# Proposed CR ISI\_RES Spec Change

Mau-Lin Wu, Tobey P.-R. Li  
MediaTek

**For IEEE 802.3ck Ad-Hoc**

# Example of Spec Methodology and Spec Limit

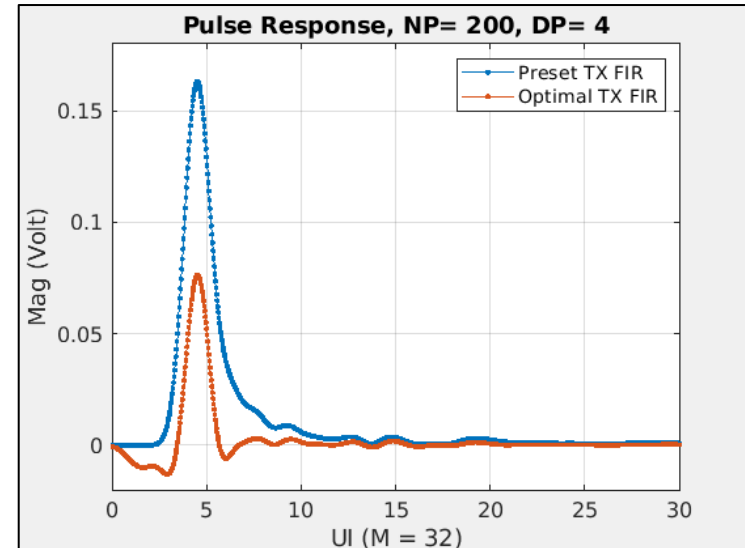
- TX FIR spec (Table 162–10)
  - Max. TX FIR peaking gain: ~11 dB

- TX compliance results

TX FIR Setting	ISI_RES (Np = 11)
Preset 1	[0 0 0 1 0]	-27.10 dB
Optional 3A	[-0.06 0 -0.14 0.6 -0.2]	<b>-29.15 dB</b>

- TX FIR can flatten the “long tail” due to dispersion, although it may cause undershoot just before and after main cursor

- Add the following paragraph after the 1st sentence of 163.9.2.6 [Thanks to Adee's contribution]
  - ISI\_RES is calculated from measurements with a single transmit equalizer setting to compensate for the loss of the transmitter package and host channel. The equalizer setting is chosen to minimize ISI\_RES.
- In Table 162-10, change
  - ISI\_RES (max) from -30 dB to -29 dB
